**Economic and Social Council**Distr.: General
28 February 2018

Economic Commission for Europe**Inland Transport Committee****World Forum for Harmonization of Vehicle Regulations****Working Party on Passive Safety****Sixty-third session**

UN Regulation No. 44 (Child restraint systems)**Proposal for Supplement 15 to the 04 series of amendments
to UN Regulation No. 44 (Child restraint systems)****Submitted by the expert from the Netherlands***

Paragraph 6.2.12., amend to read:

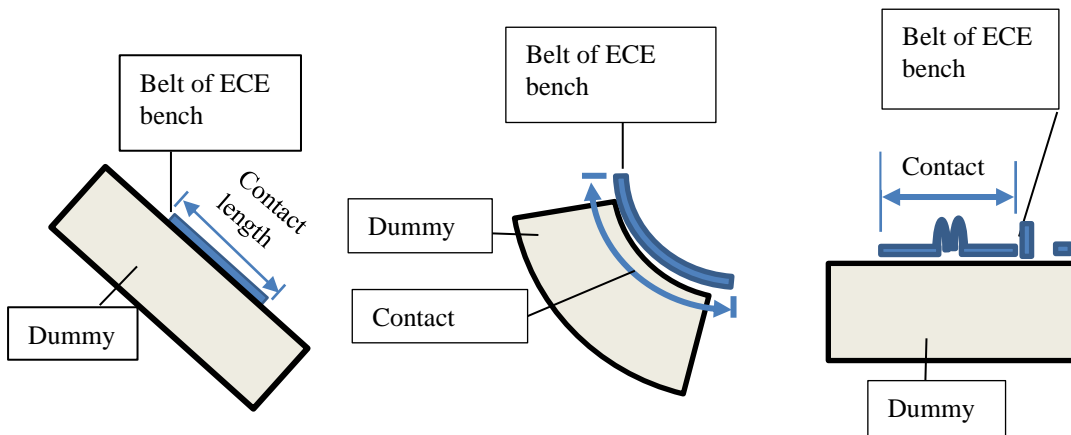
"6.2.12. In ~~the case of booster cushions~~ **non-integral child restraint systems**, the ease with which the straps and tongue of an adult belt pass through the fixture points shall be examined. ~~This goes particularly for booster cushions which are designed for the front seats of cars, which may have long semi-rigid stalks.~~

The ~~fixed simulated~~ **buckle when installed on the bench, prior to all dynamic tests, shall** ~~should not be allowed:~~

- (a) ~~to pass through the fixture points or belt guides of booster seats~~ **non-integral child restraint systems, or**
- (b) ~~to permit a lie of the belt completely different from that of the test trolley that leads to any contact narrower than 38 mm between the adult belt or simulated buckle and the child.~~

Measurement method:

The width of the contact between the belt and the dummy shall be assessed by measuring the minimum length between the effective sides of the belt. If the belt, as seen in a cross section, takes the shape of a curve, the outside contour of the curve is measured. If the belt in cross section has folds, the contact length is defined from one side to the other side of the belt.
